Access Compliance Report Public Rights-of-Way (Curb Ramps)

Main Street: RIATA_ST		Cross Street: MADISON_AVE		Location:	NE
ADA ID: RPRK220203125915	Ramp Type: Type 4 - Parallel	Initial Pass/Fail: Fail	Overall Compliance: No	Severity Score:	15
Codes/Mitigation Info/Possible Solution			Field Measurements/Component Compliance

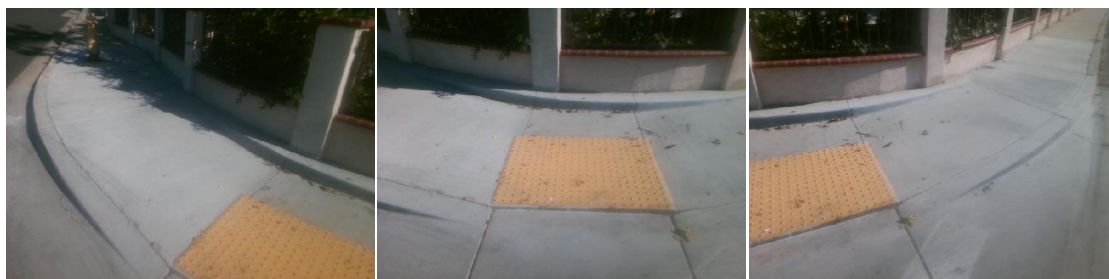
R304.3.2, STD 1115

Remove & Replace Curb Ramp With Two New Directional Ramps or Equivalent.
